APACHE AG-64

FUSELAGE ASSEMBLY

DESIGNED BY LEADFEATHER
CAD BY DZISER

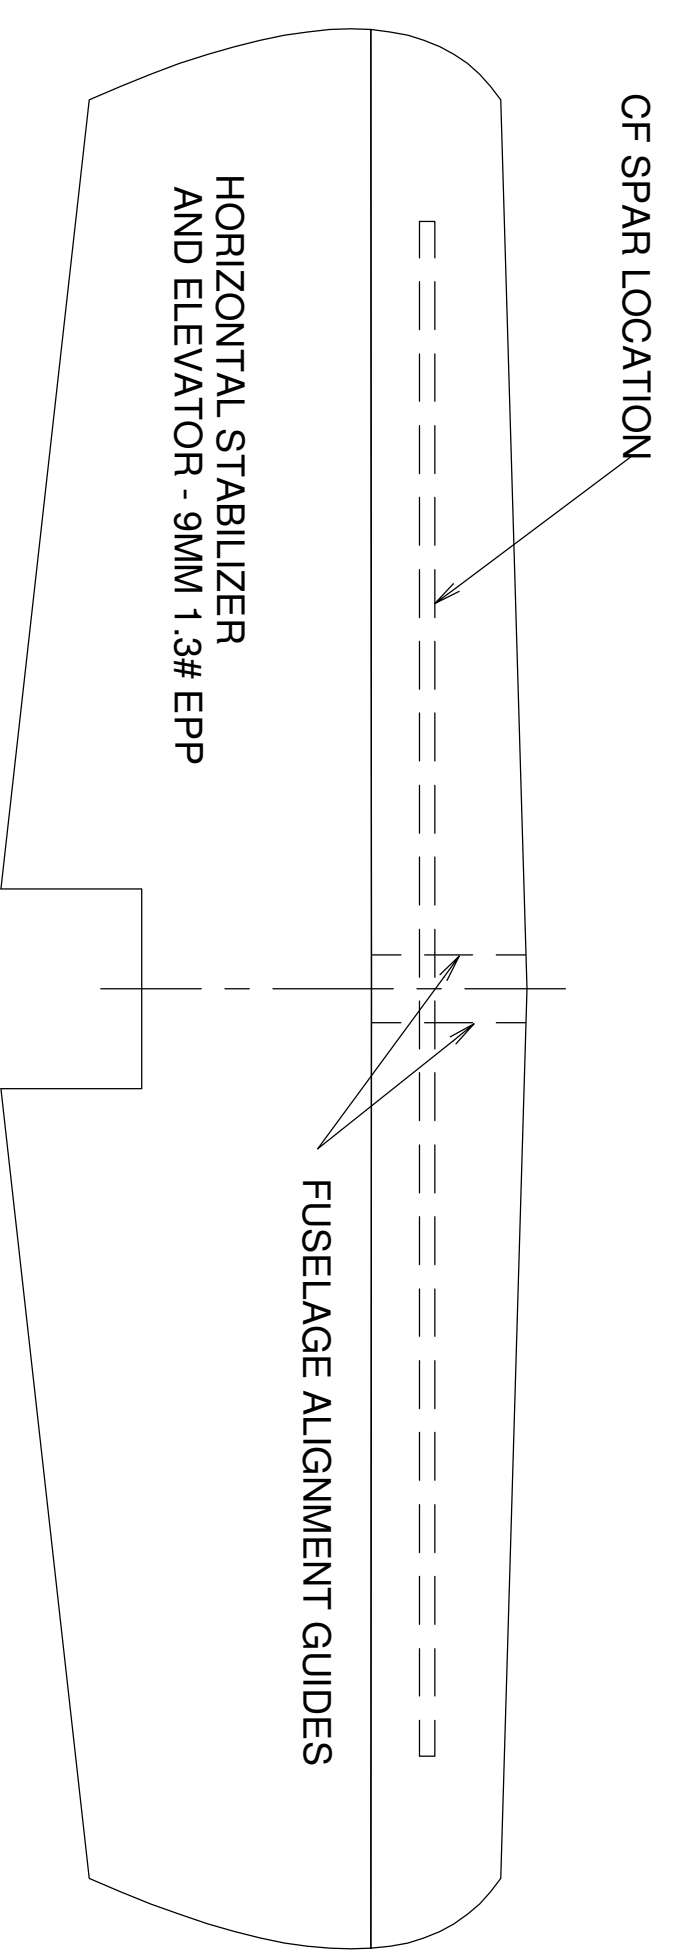
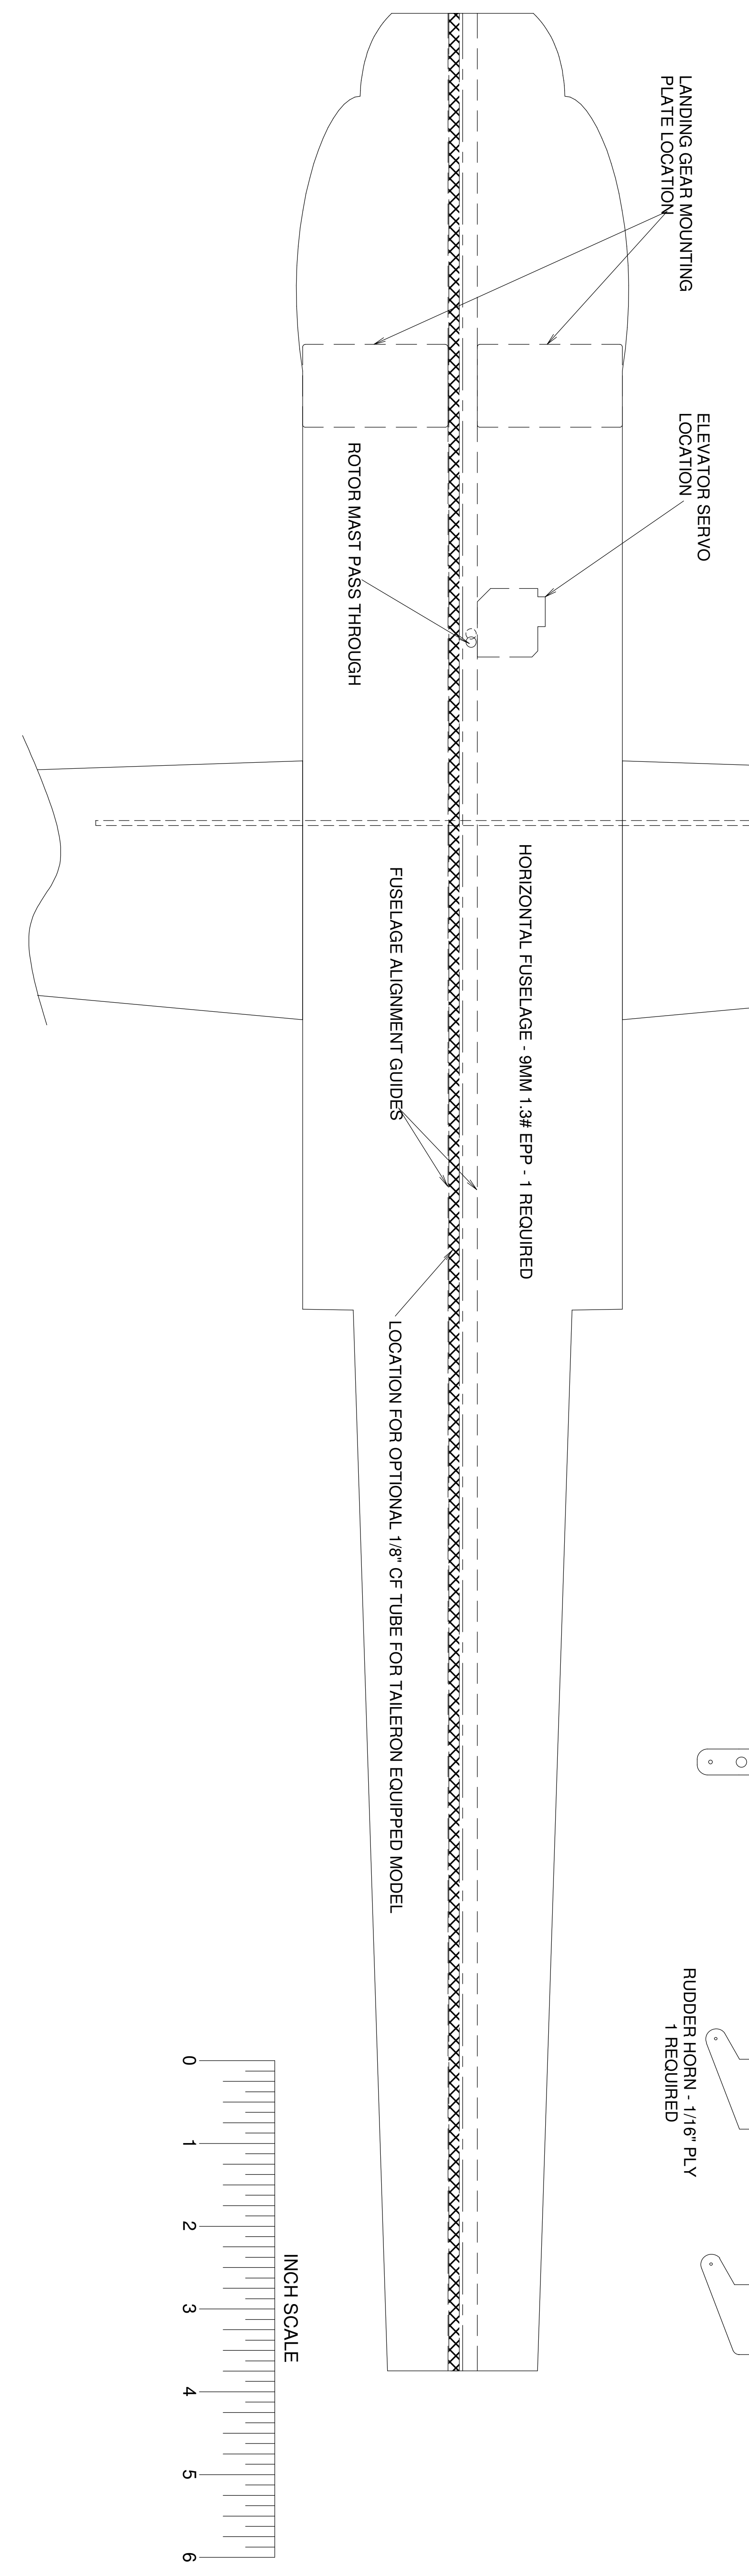
CHANGE A 21-FE-2010	UPGRADED ROTOR, MOVED CENTER OR GRAVITY FORWARD 1/4", SHOWED DETAILS FOR 4 CHANNEL PRO MOD. MOVED LANDING GEAR FORWARD 1/2".
------------------------	--
